## NOTICE OF VIOLATION

On April 27, 2023, Energy Safety conducted an inspection of SDG&E's WMP initiatives in the vicinity of the city of Alpine, California. The inspection report is enclosed herewith. Energy Safety found the following violation:

Violation 1

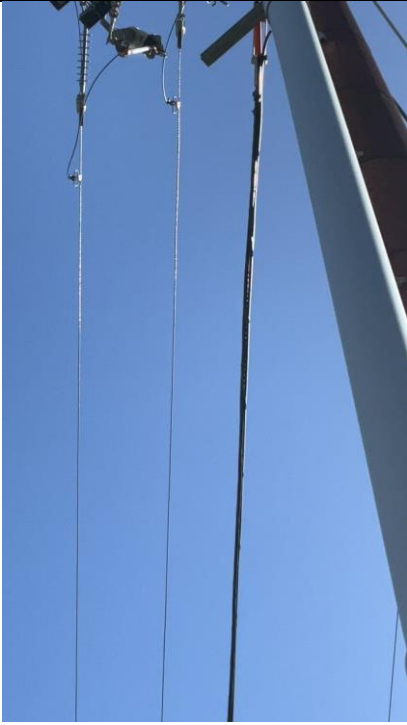
Energy Safety arrived at the provided pole ID P574883 at 23301-23567 Bell Bluff Truck Trail, Alpine, CA 91901, 32.8093471616653, -116.65015668652 and found bare wire. No covered conductor was observed where covered conductor installation was reported as completed by SDG&E. The inspector's observation is documented in Violation 1 photographs, which are attachments to this report. Photo numbers Item1GIimg1, Item1GIimg2 and Item1IA1img1 depict bare conductor where covered conductor installation was reported as completed.

1. SDG&E reported that WMP initiative number 7.3.3.3 – Covered Conductor installation as completed at this location.
2. Bare wire was observed at the provided location.
3. No covered conductor was not observed at the provided location.

**Item1IA1img1:** View of bare conductor where covered conductor installation was reported as completed.
